ORDINANCE NO. 16-8-5

An ordinance approving and authorizing the execution of Change Order No. 1 (Balancing) for Parish Project No S091101 Primrose Lift Station and Force Main Upgrades to decrease the contract amount by \$5,605.00 and decrease the number of days by 74.

CHANGE ORDER

Project Primrose Lift Station and Force Main Upgrades

ENTERGY SERVICES, INC.	
PULLBOXES	
APPROVED BY: JDS	DATE: 06-02-98
CHECKED BY: MCC	SCALE: N.T.S.
DRAWN BY: MCC	
 ENTERGY	No. UG1103011
	PLOT 1=1 SH 1 OF 1

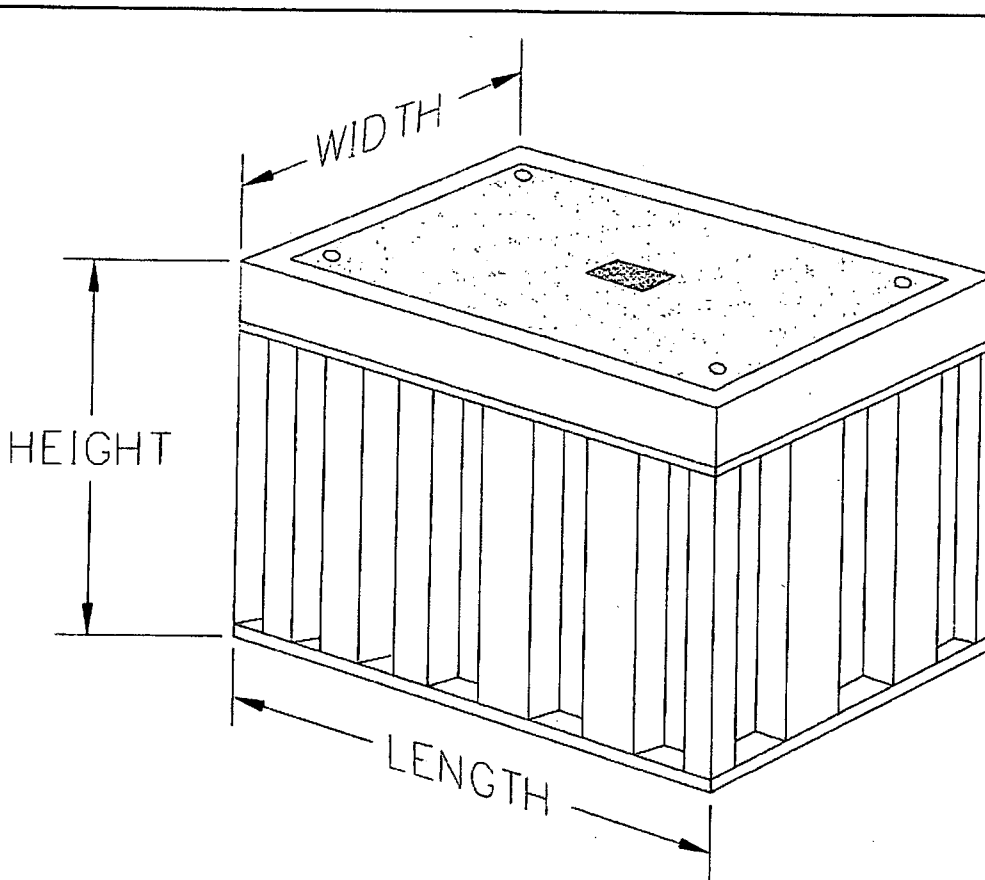
The pull box specs are in the attached documents. For a three phase primary pull box it will have to be 48" X 96" in size. Any other questions let me know and I will do my best to answer.

That is the correct size pull box. The standard continuous conduit that Entergy installs is SDR 13.5 HDPE.
